KENDALL COUNTY
ZONING AND PLATTING ADVISORY COMMITTEE
111 West Fox Street • Rooms 209 and 210 • Yorkville, IL • 60560
(630) 553-4141 Fax (630) 553-4179

AGENDA

June 7, 2022 - 9:00 a.m.

1. **Petition 22 – 11 – Tim Raymond on Behalf of TMF Plastic Solutions, LLC (Pages 9-40)**
Request: Site Plan Approval for the Construction of a 2,832 Square Foot Addition to the South Parking Lot
PIN: 01-01-200-002
Location: 12127 B Galena Road, Plano, Little Rock Township
Purpose: Petitioner Wants to Construct an Addition to the South Parking Lot; Property is Zoned M-1 Limited Manufacturing District

TMF MANAGEMENT, LLC PARKING ADDITION
CIVIL SITE PLAN

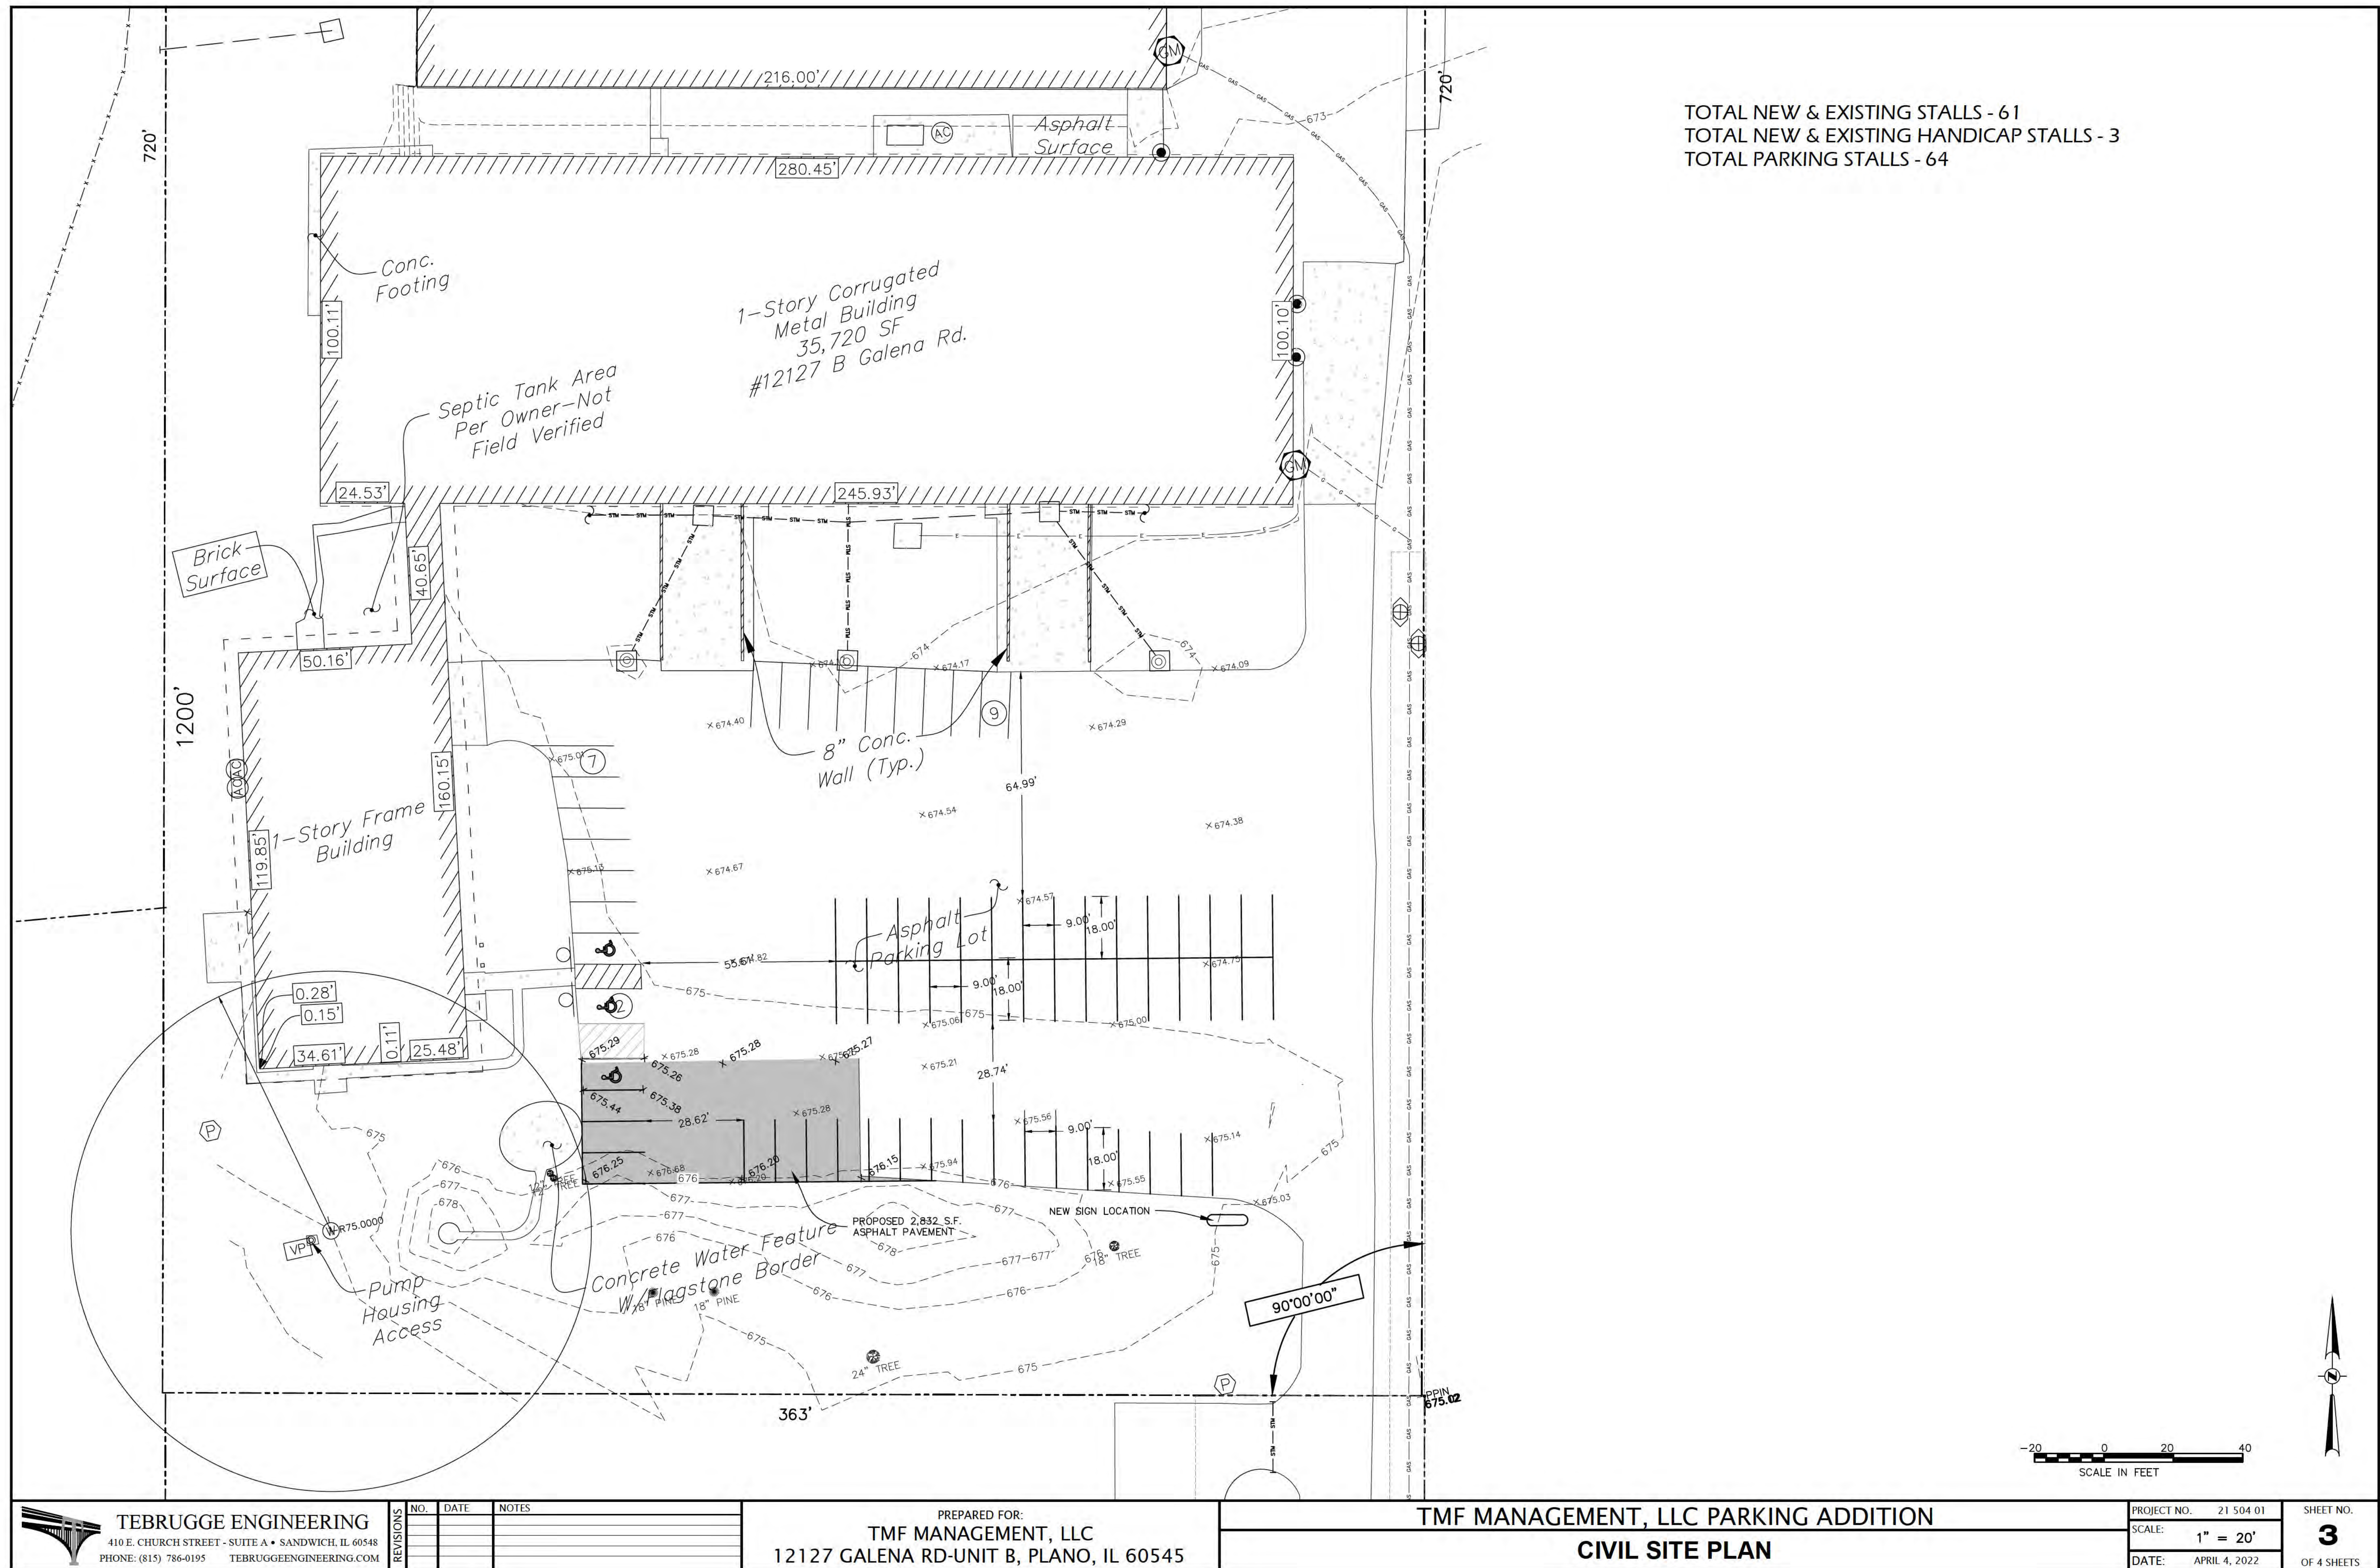
We find the fee-in-lieu calculations and engineering plans to be acceptable. Contact our office prior to construction of the parking area to verify erosion control measures.
